Flood Response to Submissions

Project Marvel

Prepared for Mapletree SR Australia Management Pty Ltd/ / 21 Nov 2024

231204

Figure 9- Flooded Area Considered for Volume Calculation in the previous stage

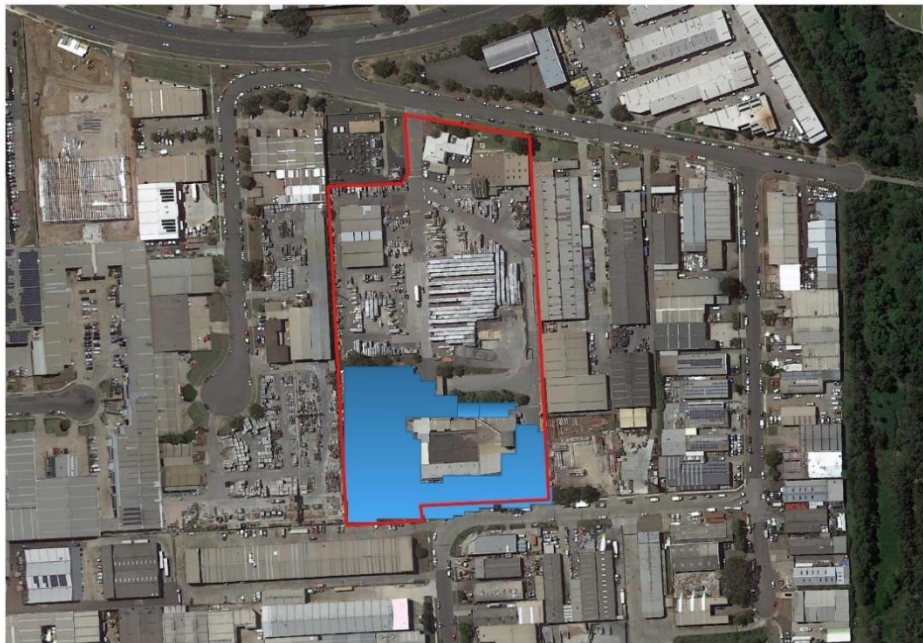
Liverpool City Council (1 July 2024)	
Comment	TTW Response
<p>The submitted Flood Impact Assessment report indicates that the development will fill the floodplain by approximately 7,500 m³. According to Council policy, there must be no net loss of flood storage volume below the 1% AEP flood level. Therefore, the design must be amended to include compensatory excavation, to ensure that the development does not result in any net loss of flood storage volume below the 1% AEP flood level. The Flood Impact Assessment Report shall be revised including the details of flood compensatory works, pre- and post-development flood storage volume calculations and a plan showing the location of flood compensatory excavation works.</p>	<p>Noted. Compensatory storage has been provided for the proposed development. Please refer to Section 2.2 of this report for details.</p>
<p>The Flood Report by TTW has not provided any detail about flood emergency response plans for the site. The report has only indicated a 'shelter-in-place' approach as the flood emergency management response for the site. However, the flood duration of the proposed development site is greater than 24 hours. Therefore, 'shelter-in-place' is not an acceptable flood emergency management response for the development site.</p>	<p>Noted. A separate Flood Emergency Management Plan (FEMP) has been prepared for the proposed development.</p>

In the initial stage of this project, calculations using the GIS package estimated that the existing flooded area within the proposed development site covers approximately 9,225 m², containing about 7,500 m³ of floodplain volume. Figure 9 illustrates the flooded area under the existing conditions, which was used for these calculations.
